DEPARTMENT OF THE ARMY
OFFICE OF THE ASSISTANT CHIEF OF STAFF FOR INSTALLATION MANAGEMENT
600 ARMY PENTAGON
WASHINGTON, DC 20310-0600

RE: Permittee Initiated Interim Measures Report, Parcel 6, Response to August 21, 2017
Disapproval Letter, Fort Wingate Depot Activity, McKinley County, New Mexico
EPA #NM6213820974, HWB-FWDA-16-011

New Figure 6-2

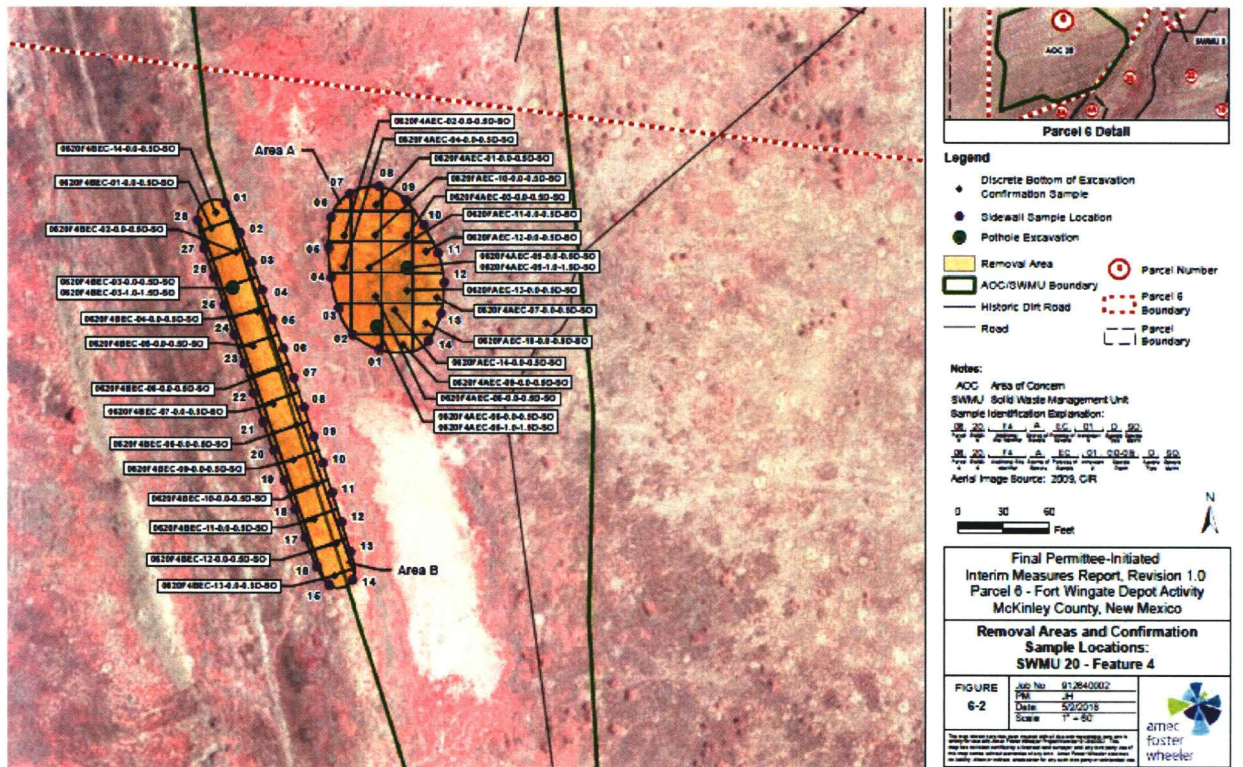
NMED Comment: The Permittee is required to collect discrete samples every 20 ft from the sidewalls of the excavation when debris is removed from depths greater than one foot bgs according to the May 29, 2015 letter. It appears that no sidewall samples were collected even though the excavation depth exceeded one foot bgs in several areas. The Permittee should have collected sidewall samples from areas where the excavation depths exceeded one foot bgs. Collect sidewall samples from the native soils at the limits of excavation and analyze them for all analytical parameters specified above. In addition, the Permittee is required to collect discrete samples at the base of the excavation using a 20-ft by 20-ft sampling grid according to the letter. The number of base samples collected by the Permittee appears to be less than the number of base samples required by the NMED (i.e., one sample per 400 ft²). Explain the variance in the revised Report; otherwise, additional base samples must be also collected and analyzed. Any additional base samples must be collected from native soils directly beneath the backfill. Include the analytical results and discussion in the revised Report. If the base of the excavation is sloped such that sidewall sampling is not possible, clarify the conditions in the revised Report. Provide photographs of the Area A excavation. Revise the Report to reevaluate the risk and propose additional corrective action, as necessary.

The sample locations, as shown on Figure 6-2 of the revised report, were discussed and approved by NMED via email correspondence (included in Appendix A of the Report). The risk evaluation was also revised to incorporate the results of these samples.

The removal action for SWMU 20 Feature 4 was generally a surface debris removal action. In some areas, additional excavation continued into the underlying soils extending to depths exceeding 1 foot in Area B and several small areas up to 2 feet in Area A. To comply with NMED's request, perimeter soil samples were collected every 20 feet around both Areas A and B.

Section 6.0 has been re-written to include the results and risk analysis for all samples including new sample locations Shown on Figure 6-2.
